Well Name	Well Number	US Well Number	Lease Number	Case Number	Operator
RIO BLANCO 4-	103H	3002554247	NMNM92199	NMNM139078	DEVON
RIO BLANCO 4-	106H	3002554250	NMNM19142	NMNM140034	DEVON

Sundry ID: 2843184

Type of Action: APD Change

Procedure Description: Engineering Only - Devon Energy Production Company L.P. respectfully requests the following changes to the approved APD: Offline BOP/Stump testing variance request. Batched wells on Rio Blanco 4 Wellpad 5. No other requested changes to drilling program. Please see attached drill plan with offline cement verbiage and Break Test Variance_Offline BOP variance request document.

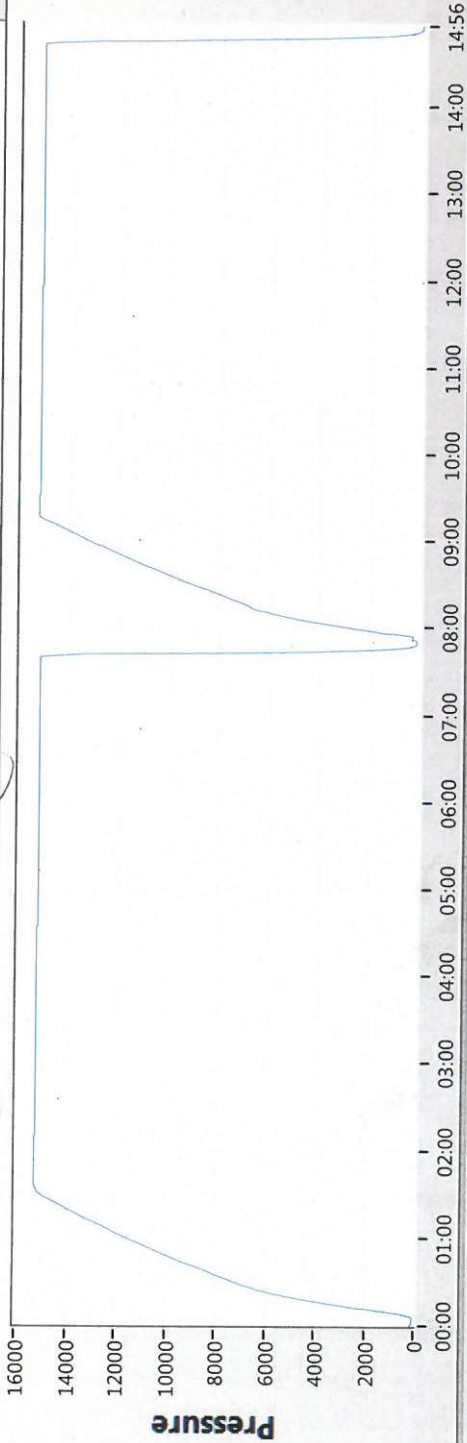
Devon Energy requests to perform offline BOP stump testing and offline BOPE testing. All pressure-containing and pressure-controlling seals will be tested either online or offline as denoted in the table below and per BLM approval during initial BOP test following test pressure requirements set forth in 43 CFR 3172. Remaining components not tested offline or on the stump will be tested within 72-hours when the BOP is connected to the wellhead. If stump testing exceeds 72-hour window prior to connecting to the wellhead, the BLM will be notified and either stump testing restarted, or the BOP being tested online. The BLM will be contacted 4hrs prior to a BOPE test. The BLM will be notified if and when a well control event is encountered. In the event stump testing is not utilized, then a full BOPE test would be conducted.

Components	Offline	Offline, BOPE	Break	Online
Upper Rams		X	X	X
Blind Rams		X		X
Lower Rams				X
Outside Kill Valve		X	X	X
Inside Kill Valve		X	X	X
Kill Line Check Valve		X	X	X
Inside Choke Valve		X	X	X
HCR		X	X	X
Kill Line	X			X
Annular		X		X
Choke Manifold Valves and Hose	X			X
Mudline (Mud Pumps, Rig Floor Valves, Kelly Hose, Mud Line)	X			X
Standpipe Valve	X			X
IBOP (Upper and Lower)	X			X

Devon requests offline BOPE testing for the following components: Upper Rams, Blind Rams, Kill Valves, Choke Valves, and Annular

Remaining well control equipment components will either be tested offline or online, per BLM approval

Remaining BOPE will be tested online within 72-hours from completing the offline BOPE component testing

All Full Tests not completed "Offline" or "Offline, BOPE" are required to be complete Online

Devon requests Break testing as stated above for SK tests, not including production hole

Annular Preventer will be tested to minimum of 70% RWP and higher than MASP during initial BOP test

Pressure testing is required for pressure-containing connections if the integrity of a pressure seal is broken during a break test

All Previous COAs Still Apply. Variance request procedure is approved as written, please see below general conditions for variance.

- BOPE Break Testing is ONLY permitted for 5M BOPE or less. **(Annular preventer must be tested to a minimum of 70% of BOPE working pressure and shall be higher than the MASP)**

- BOPE Break Testing is NOT permitted to drilling the production hole section.
- Variance only pertains to the intermediate hole-sections and no deeper than the Bone Springs formation.

Operator has been **(Approved)** to test the BOPE offline.

The BOPE offline testing shall be stationary during pressure testing.

Online BOPE testing should commence within 72 hours of offline BOPE testing completion. Notify the BLM if interval exceeds 72 hours.
